# Record of Appeal for Public Space Permit for 701 10<sup>th</sup> St NE

**Re: Application for public space permit at 701 10<sup>th</sup> St., NE**

**Re: Appeal of public space permit (701 10<sup>th</sup> St., NE)**

**Exhibit A**

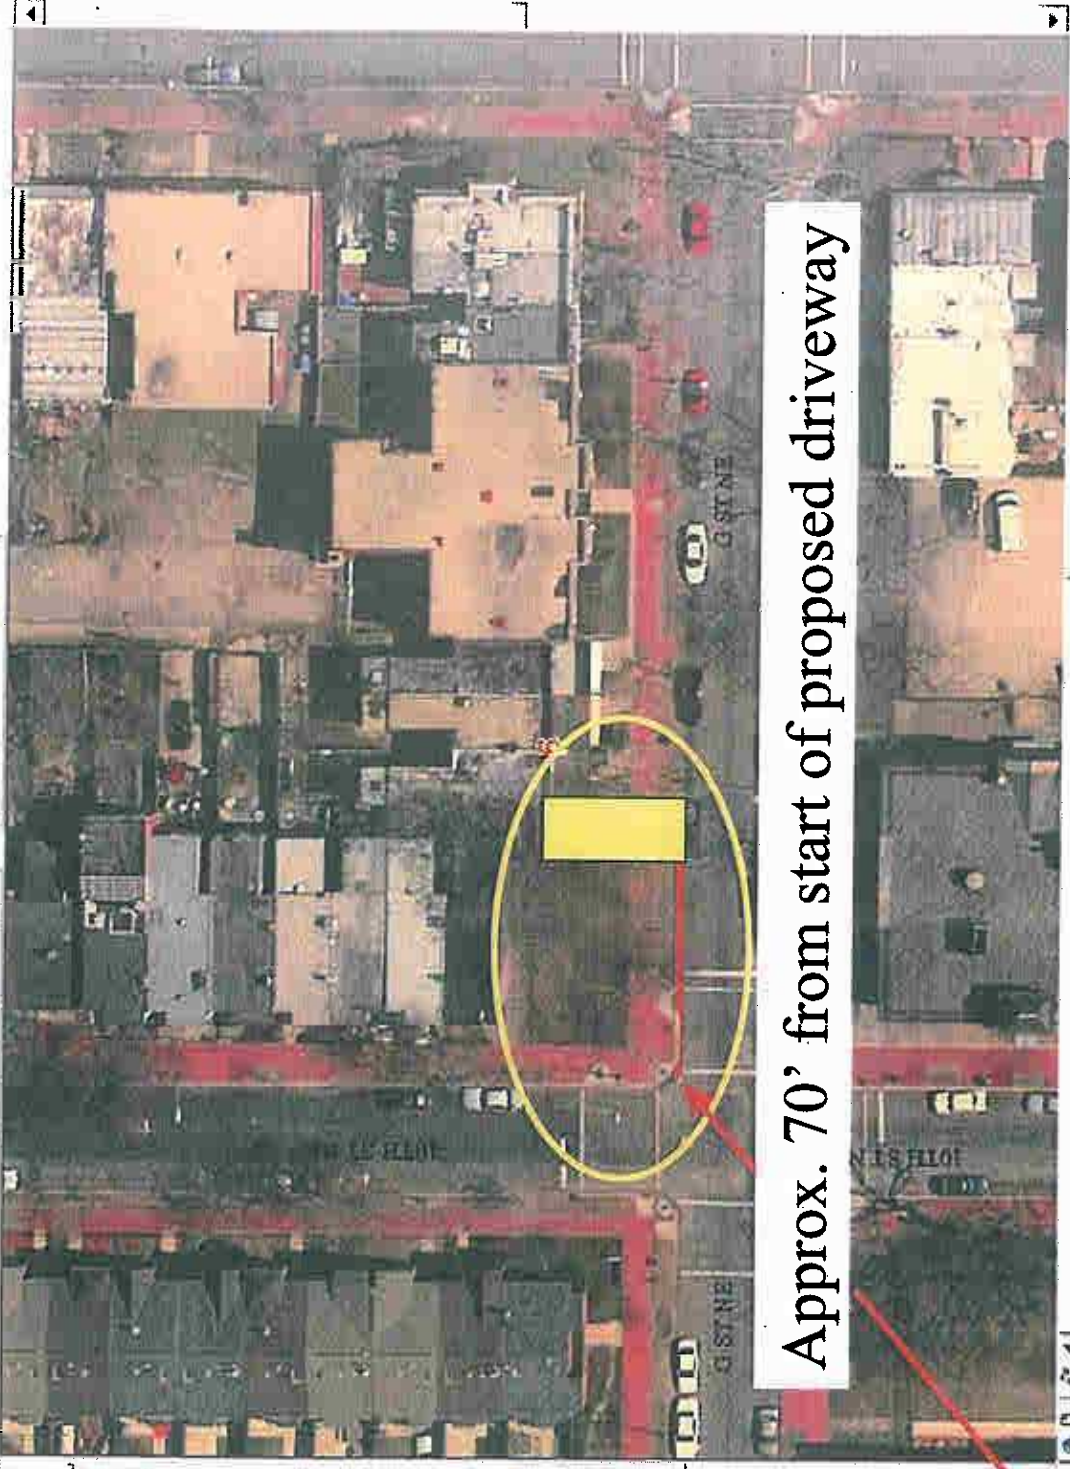
DDOT granted the Permit on the basis of incorrect measurements. All but one of the distance measurements in the administrative record were apparently taken on-site. Inexplicably, the only measurement for which DDOT relied on estimates from an electronic database instead of on-site measurements was the one for the distance from 10<sup>th</sup> Street, NE, to the edge of the proposed driveway. On the basis of this electronic estimate, DDOT concluded that the 10<sup>th</sup> Street, NE, intersection was “Approx. 70’ from start of proposed driveway.”<sup>1</sup>

DDOT’s electronic estimate is grossly incorrect. The Contractor’s own Surveyor’s Plat shows that a 24-foot wide driveway will be somewhere between 30 ft. 11 in. and 47 ft. 8 in. from the intersection.<sup>2</sup> The actual measured physical distance from the intersection to the edge of the permitted driveway is, at most, 57 feet.<sup>3</sup> In either case, the distance from the intersection to the

<sup>1</sup> See Exhibit A, attached. DDOT’s electronic approximation shows the driveway overlapping the neighboring property, which results in a greater distance between the intersection and proposed driveway.

Approx. 70' from start of proposed driveway

DIAGRAM OF ACTUAL MEASUREMENTS  
AT 701 10TH ST., NE

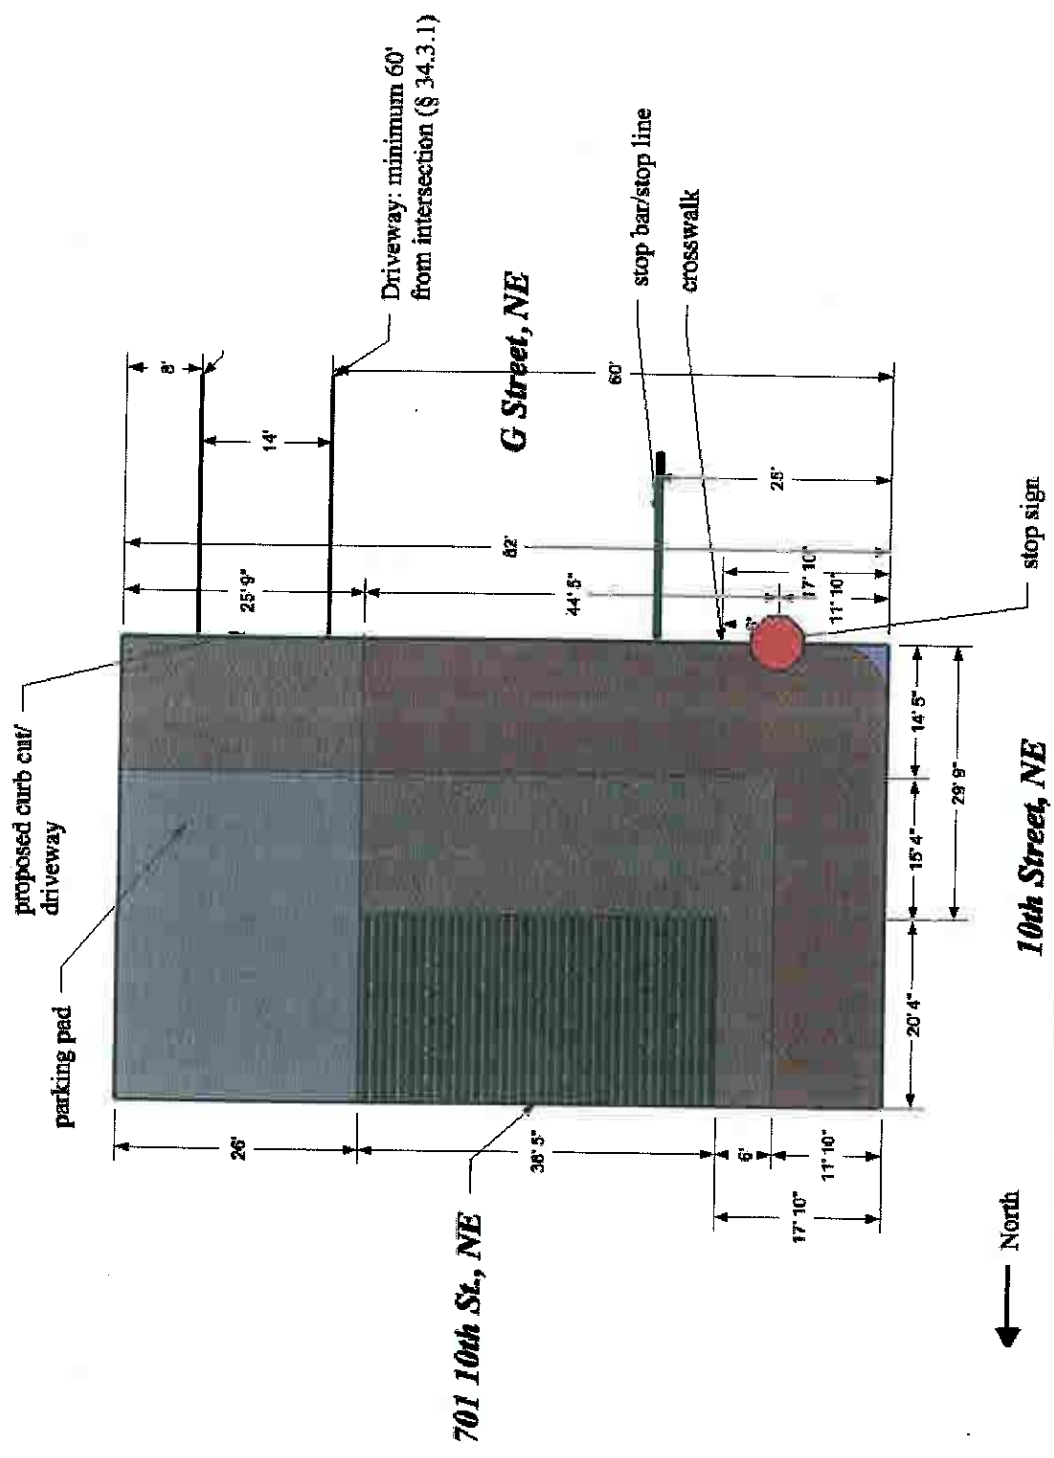
<sup>3</sup> See Exhibit B (Diagram of Actual Measurements at 701 10<sup>th</sup> St., NE, enclosed).

The edge of any driveway must be a minimum of 60 feet from an intersection.<sup>8</sup> In addition, in DDOT's consideration of the Permit application, DDOT's Traffic Services Administration ("TSA") determined that, in this case, "[t]he driveway must be a minimum of 25 feet [wide] so that both vehicles could move freely by each other" in the proposed two-car driveway.<sup>9</sup> However, at the Property, the actual distance from the intersection at 10<sup>th</sup> St., NE, to the furthest

edge of the property line is only 82 ft. Therefore, any driveway that is 25 feet wide necessarily will fall within 60 feet of the intersection.<sup>10</sup> In short, it is impossible for *any* two-car driveway at the Property to comply with both TSA's requirements and DDOT's Design and Engineering Manual.

<sup>10</sup> The calculation is as follows: 82 feet less 25 feet is 57 feet.
